City of Tacoma
Department of Public Utilities
Power Division

**Cowlitz Falls North Shore Collector Downstream Fish Evaluation
RFP Specification No. PG16-0558F**

QUESTIONS and ANSWERS

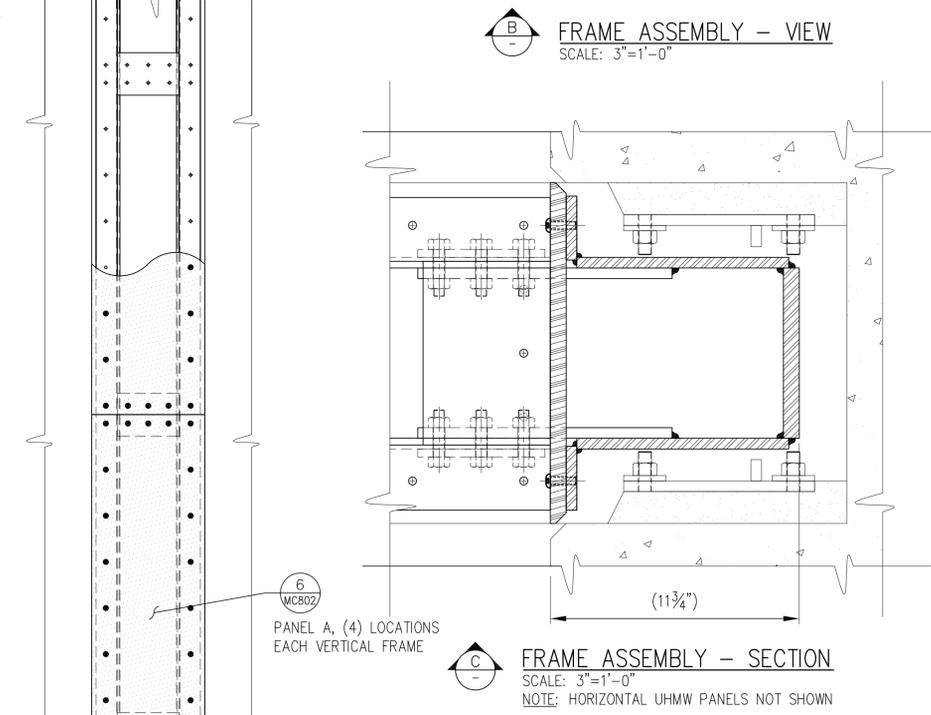
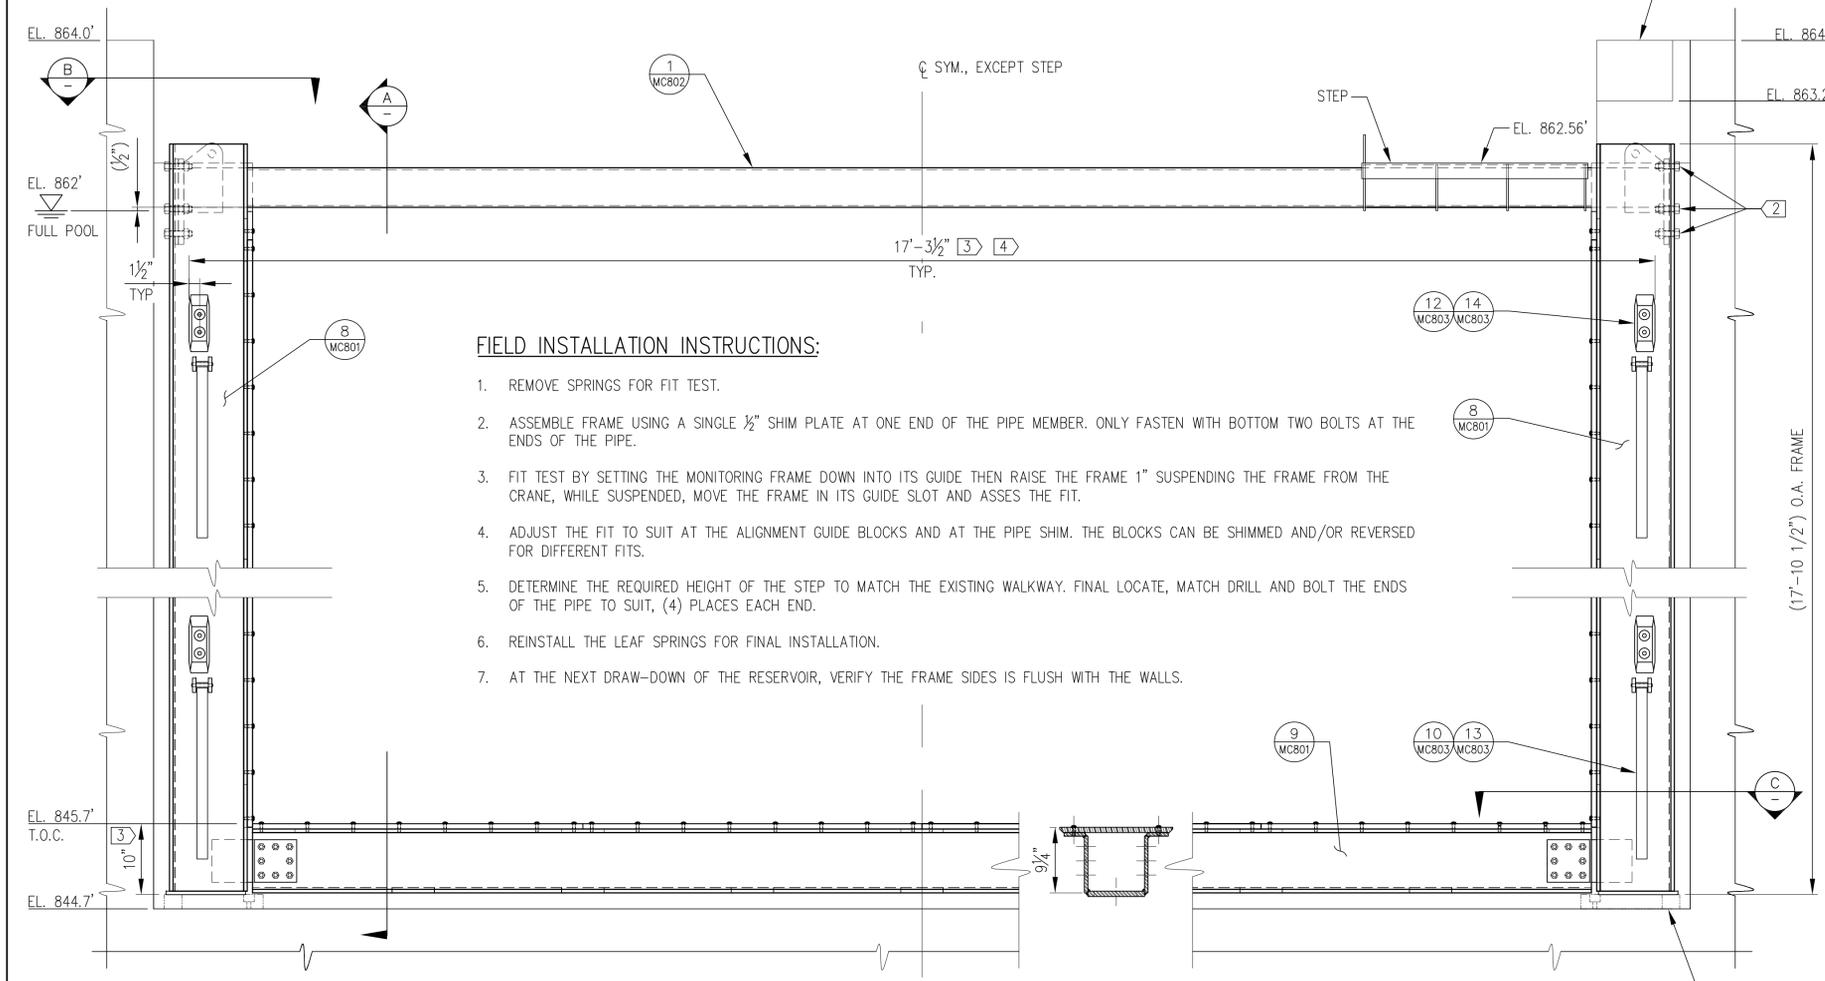
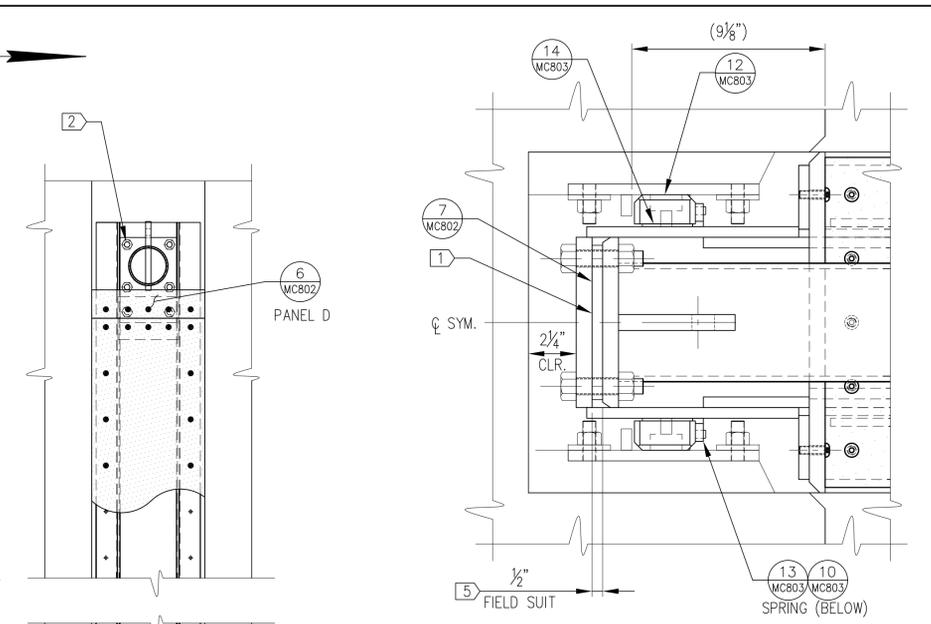
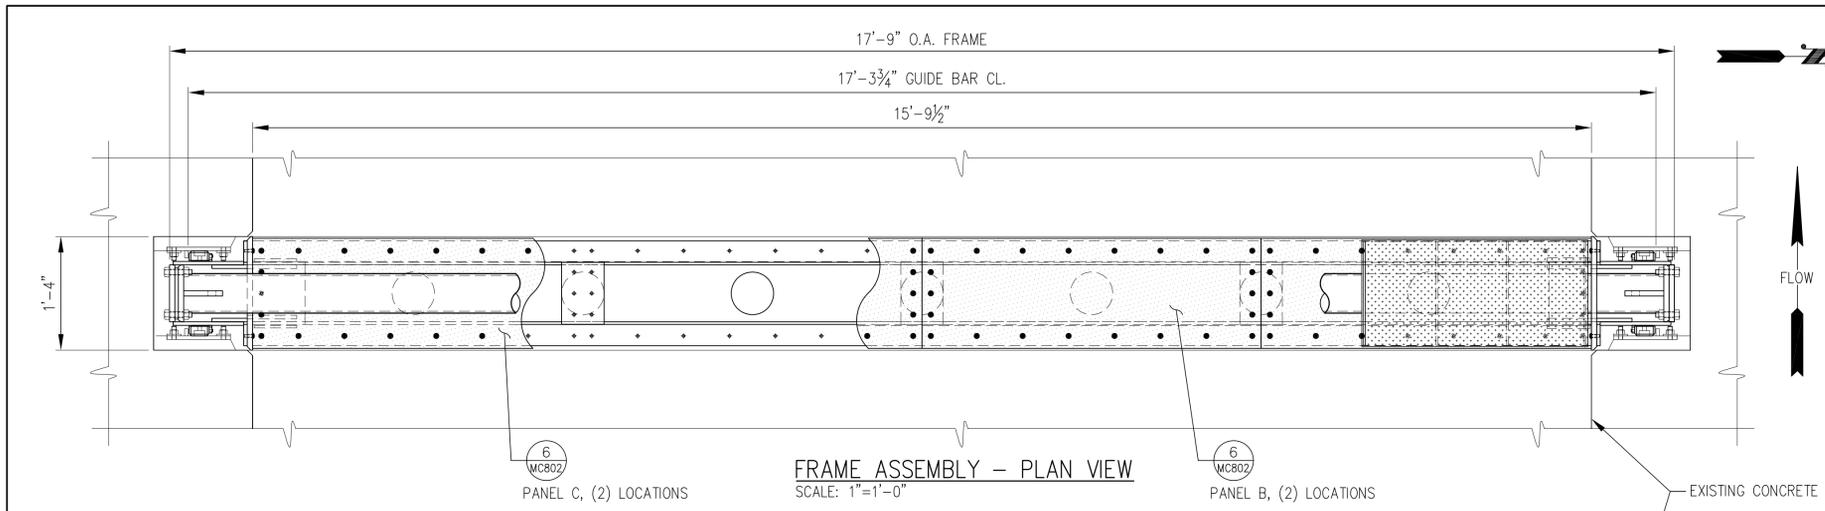
Question 24: What does the monitoring frame look like?

The monitoring frame is constructed from aluminum c-beam, with a UHMW face. It fits into a channel in the fishway, with the UHMW face flush with the walls of the fishway. Interstitial space provides room for instrumentation, and the UHMW face can be drilled or cut to accommodate antennas, hydrophones, etc. Drawings provided at the end of this Questions and Answers document.
